End-of-Burst Indication

Current Approach (D1.8023)

Figure 92-16—ONU burst transmission termination

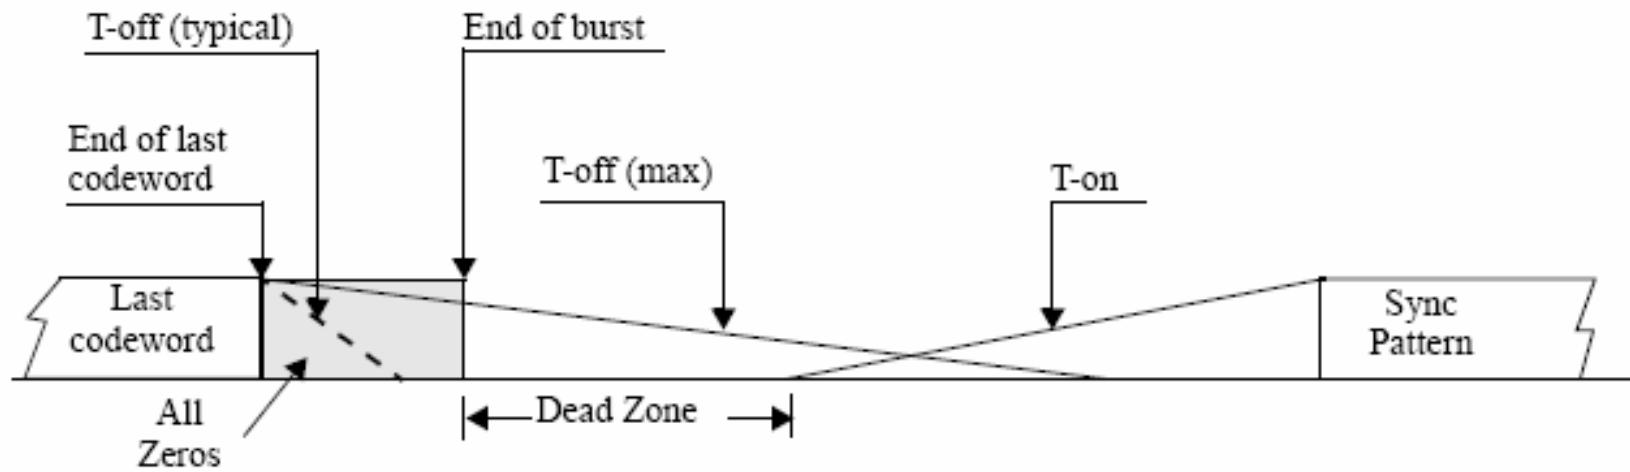
The Problem with the Current Approach

- When the Laser Diode is Turned OFF, there is no meaning for any transmission '0' or '1' anymore
- When the Guard Time, at the OLT Receiver, is longer than the CID Time Constant, the stability of the Limiting Amplifier output depends on the architecture of the LIA and the input Noise
- Signal OK – Signal_OK indicates that the input signal is below its threshold
- The AC Coupling at the OLT receiver provides stable output as function to the Time Constant (RC)
- AC Coupling receiver designed to support up to 64 bits of CID
- In order to receive consecutive 2 Blocks of '0', the Time Constant should support CID of 2 Blocks (132 bits)

51.2.3.1 Semantics of the service primitive

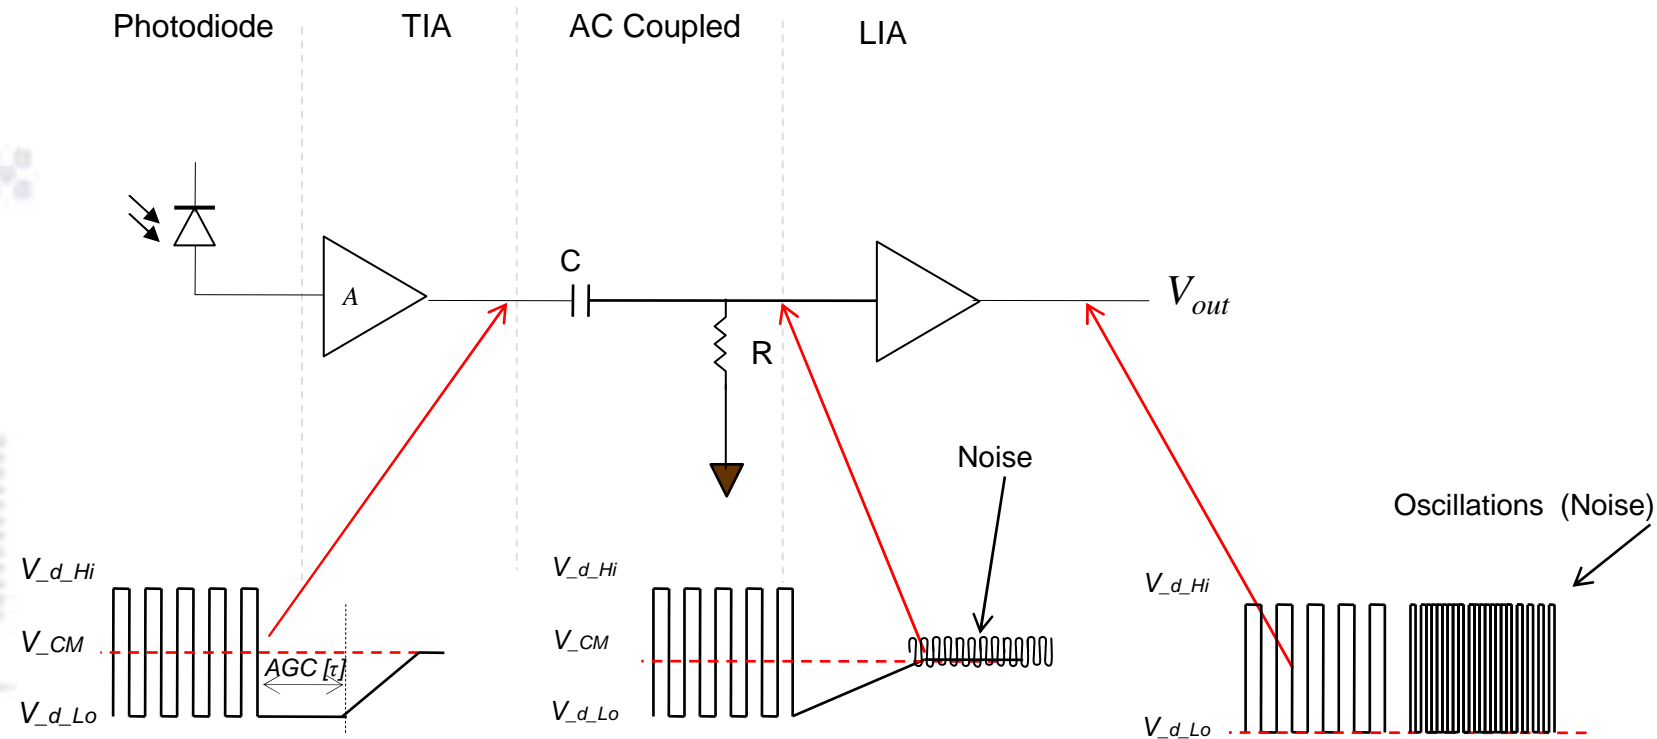
Why we can't trust Signal_OK

- According to 802.3 Clause 51:

The SIGNAL_OK can take one of two values: OK or FAIL. A value of FAIL denotes that invalid data is being presented to the PMA client. A value of OK does not guarantee valid data is being presented to the PMA client.

The Alternative: Change to Tx State Diagram

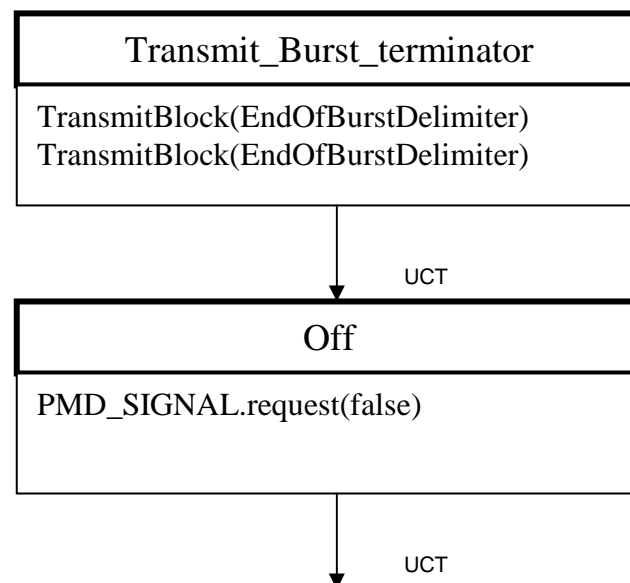
The Transmission_burst_delimiter state now appears **before** laser turnoff in Fig. 92-16

EndOfBurstDelimiter can be any balanced 66b pattern – so 10 followed by 0x5555555555555555 is suggested

The Alternative: OLT Sync FSM (92-19)

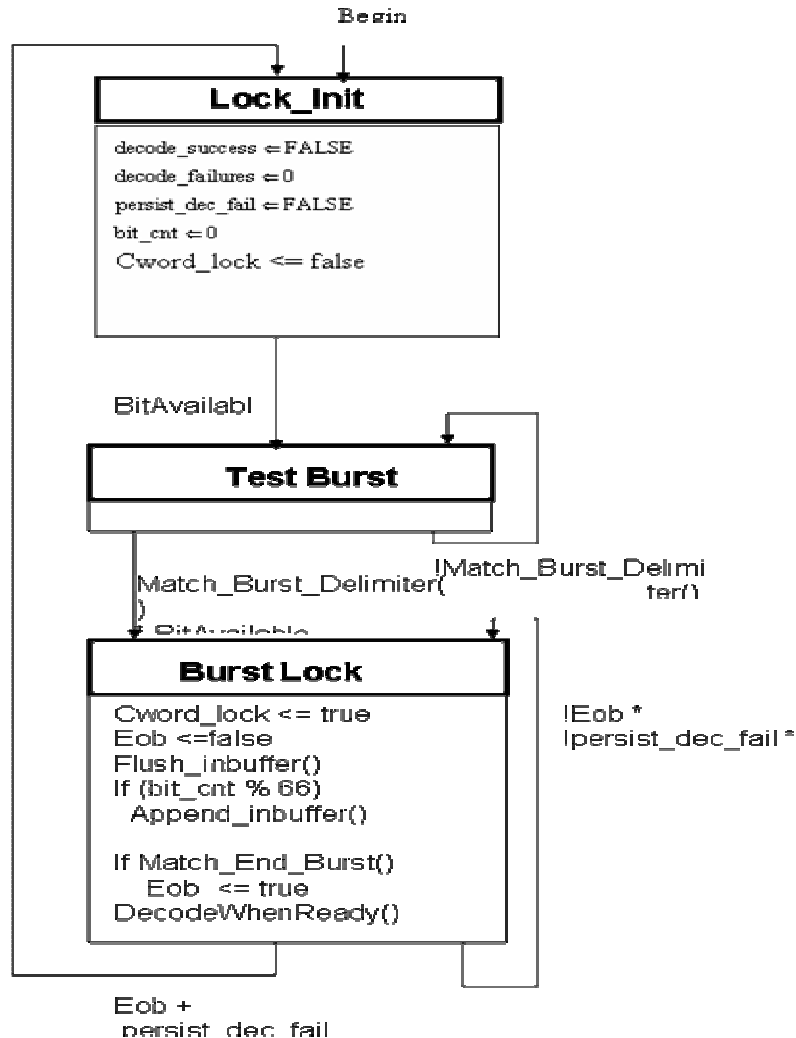
BitAvailable:

Flag that returns true when and only when there exists an unprocessed bit from the PMA

Match_Burst_Delimiter():

returns true when and only when the Hamming Distance between the Start-of-Burst Delimiter and the last 66bits received is 12 or less

Match_End_Burst():

returns true if and only if a full FEC codeword has been accumulated and the Hamming Distance between the End-of-Burst Delimiter and the last 2 blocks accumulated is 14 or less
